Glasair Service Bulletin 1

Subject: Nose Gear Scissors

Models Affected: RG Landing Gear #01-70

MODEL	ASSEMBLY NAME	REVISION	DATE	VOLUME	PAGE
GLASAIR RG	SERVICE BULLETIN 1		9/6/84		1

FIGURE (1-1)

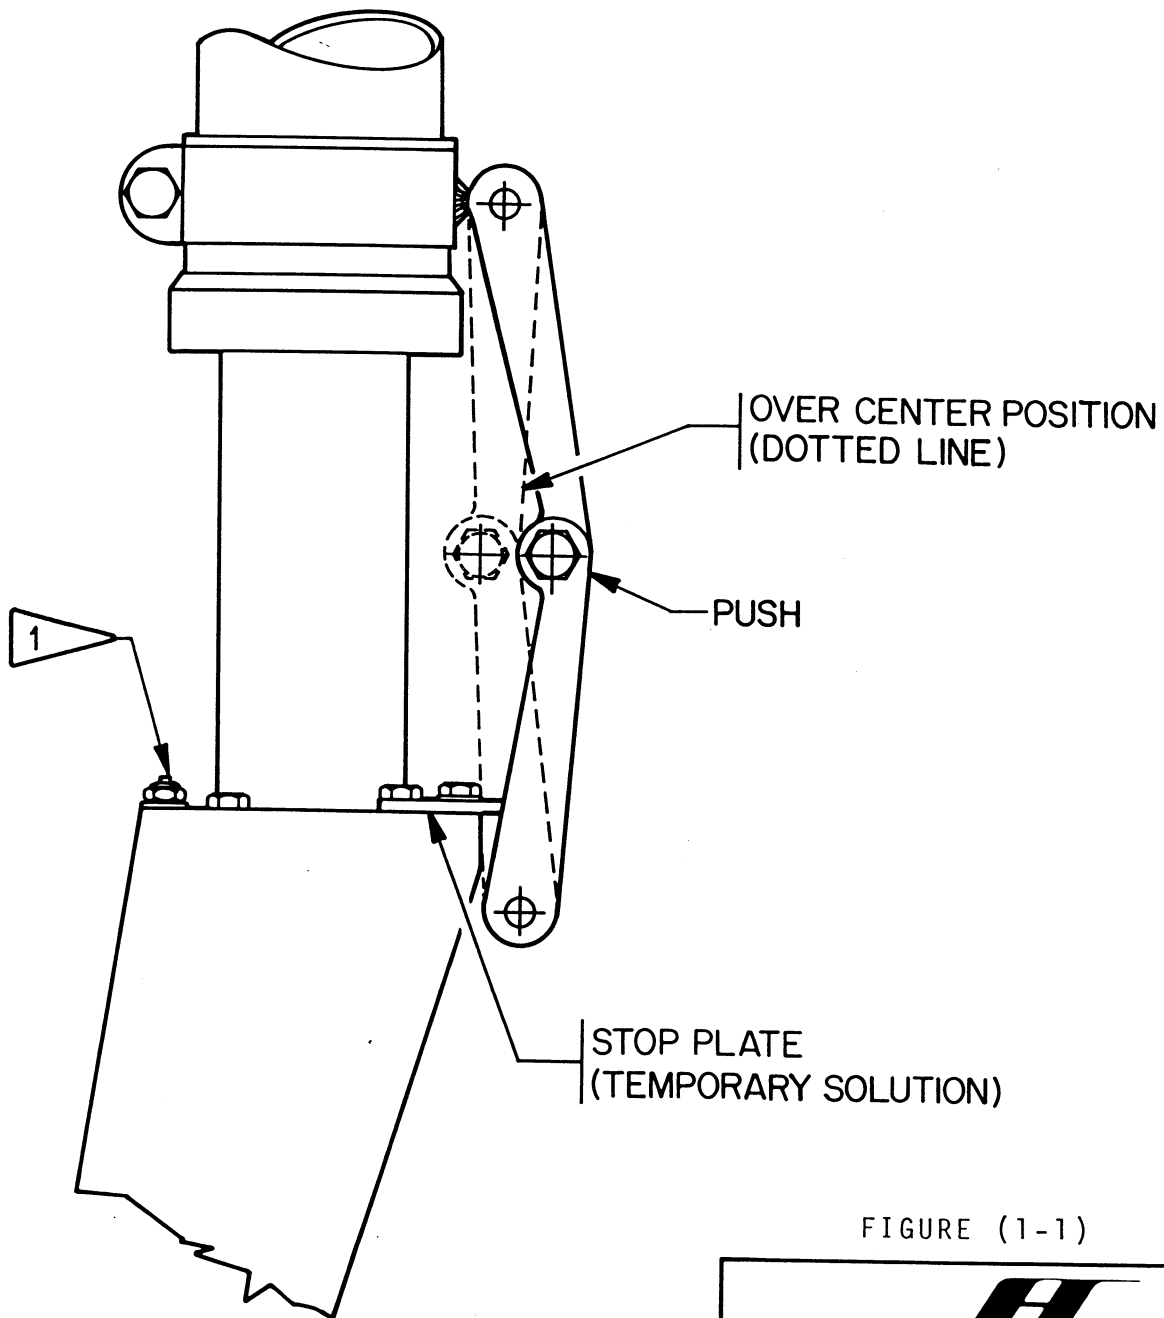
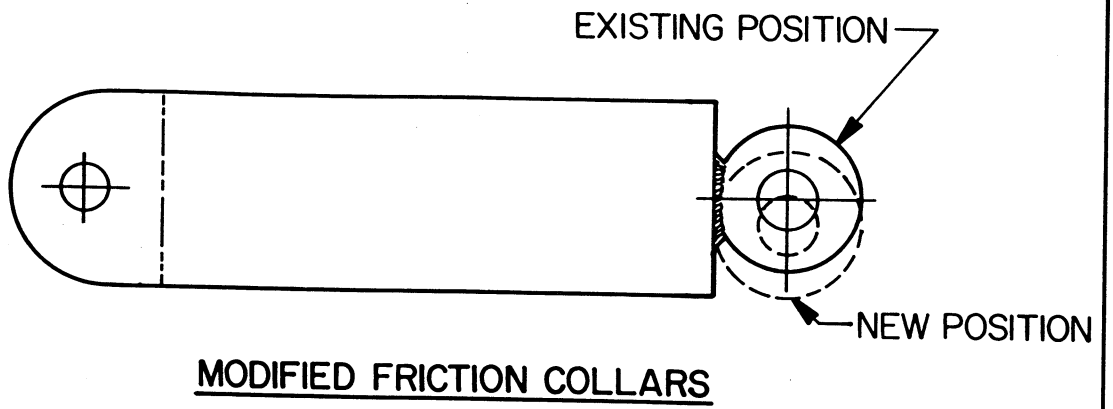
On some of the nose gear struts in the first production run, the upper and lower pivot points for the scissors are too far apart, allowing the possibility of the scissors rotating over center and locking the oleo strut in its fully extended position.

To check your nose gear strut, first bolt the aft ends of the shimmy damper friction collars together using the AN hardware provided, as shown in FIGURE (3-23) on page 3-37 of the RG Appendix. Now, with the strut fully extended, push inward on the center pivot point of the scissors, as shown in FIGURE (1-1), using firm thumb pressure. If the scissors rotate to the over center position, shown by the dotted line in FIGURE (1-1), then a problem exists which must be remedied. Be aware that, with the gear struts fully extended, the nose gear scissors are normally in a flatter position than the main gear scissors, and also that rubber O-rings are used in the oleo struts to cushion the extension stop. So, do not use excessive force to accomplish this test; just use firm thumb pressure.

The aft bolt that holds the nose gear fork to the oleo strut, referenced by Flag #1 in FIGURE (1-1), may rub on the tire. This bolt should already have been installed with the head toward the tire but, in some instances, there is still too little clearance. If this is the case, remove the bolt and countersink the bolt hole (on the side toward the tire) for an AN509-10R14 screw. We will supply the screw, if needed.

If your testing shows a problem to exist with the main gear scissors, we will exchange your shimmy damper friction collars with a modified set on which the scissors boss has been lowered 1/8". The collars can easily be replaced with the nose gear struts mounted on the airplane. These modified parts should be ready for shipment in the near future.

If you planned to have your airplane flying before parts are available, fabricate a stop plate and bolt it to the nose gear fork, as shown in FIGURE (1-1), to keep the scissors from rotating to the over center position. This stop plate can be removed after you receive and install the modified friction collars.

NOTE: In extreme cases all three of the aft bolts will need to be inverted and countersunk.
